URBAN DESIGN COMMITTEE STAFF REPORT

APPLICATION NUMBER	Urban Design Record #24052
APPLICATION TYPE	Advisory Review and Final Action
ADDRESS/LOCATION	NW Corner 26 th and U Streets
HEARING DATE	April 02, 2024
ADDITIONAL MEETINGS	--
APPLICANT	Aaron Burd, amburd76@gmail.com
STAFF CONTACT	Arvind Gopalakrishnan, 402-441-6361, agopalakrishnan@lincoln.ne.gov

Advisory review for 8 new townhomes at the northwest corner of 26th and U Streets adjacent to the Hawley Local Landmark District.

TYPICAL REAR ELEVATION

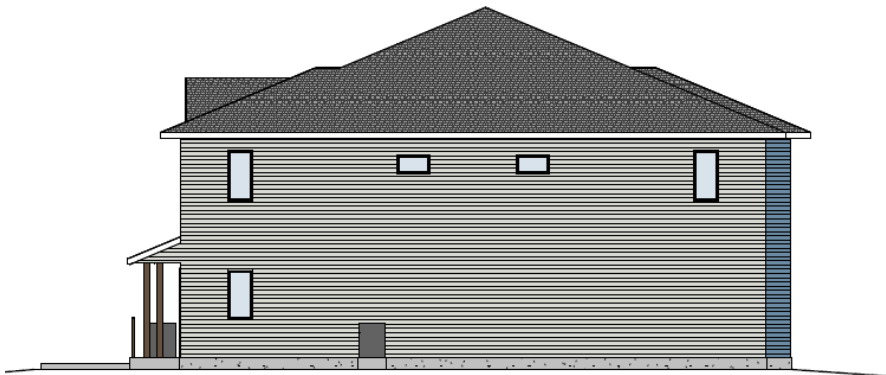
Roof pitches in the area are steeper gables like a 9/12 pitch and steeper hip roofs which commonly have a dormer. The proposed roof configurations alternate between hip and gable to break up the elevations and blend with the mix of roof types found in the district.

Compatibility per Staff Analysis: *Compliant. The structure is designed to fit well within its context. The front facade is broken up by alternating colors and gables, and offsetting the alternate units a few feet from each other.*

- It would be good if it could look less new and a bit more integrated into the neighborhood. Internal grills would be nice, and though it may not be necessary or code because of the short elevation of grade, would be to still have some railings up front on the porches.

- Members like to see housing going in but would like to see more dimension on the exterior façade. It would be good to do a one-over-one double-hung window or add dimension to the window or main elevations such as a porch rail to match the neighborhood. The style of railing isn't as critical as the presence of a railing. It helps to break up the flatness and neutralness of the façade and gives a nod to architectural styles in the neighborhood.
However, the porch is 5' wide and adding a railing would considerably reduce the usable space. It can be used as a stoop without railing. In staff's opinion, the plants around the porch will add to the aesthetic and hence, might not require railings.

- A member asked if the window casing could be differentiated color-wise, to differentiate it from the siding color. In the design, the trims are the same color as the siding, and the windows would be white.
Currently, most houses in the block and district feature trims either in white or contrasting colors with the siding. Staff suggests standardizing all trims to white, or contrasting colors. This adjustment will enhance depth in the facade and make the siding colors stand out more effectively.

- A member stated the typical side elevations have major view potential, especially on 26th Street and those look bleak. Worth stated to get better window patterns on those facades as well. Otherwise, they are relatively blank and don't contribute much to the neighborhood.
The applicant stated one side is the garage and they cannot have windows due to LES guidelines since they are next to transformers. They had designed more windows originally but had to remove them.

Overall, the HPC recommended approval of the project as presented is a contribution to the neighborhood and the developer should apply design elements that match stylistically to the district, which would include porch railings styled at the applicant's discretion, window configurations, window grills, and considering a siding reveal, and reviewing the non-primary façade.

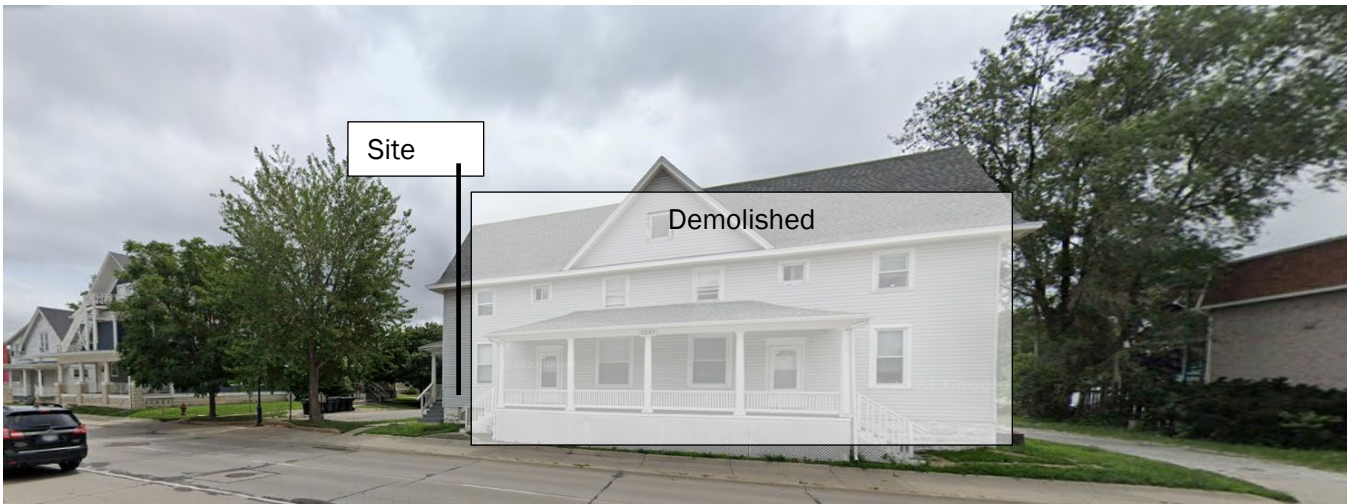
There are 2 mechanical units placed together in front of the main facade on U St as well as on Vine St, but are screened with a 48" tall fences. The units will not be visible from the streets.

Compatibility per Staff Analysis: *The plans and perspectives do not show the existing trees.*

However, the proposal shows a total of 6 trees that would be planted as part of the project, out of which 4 are along 26th St.
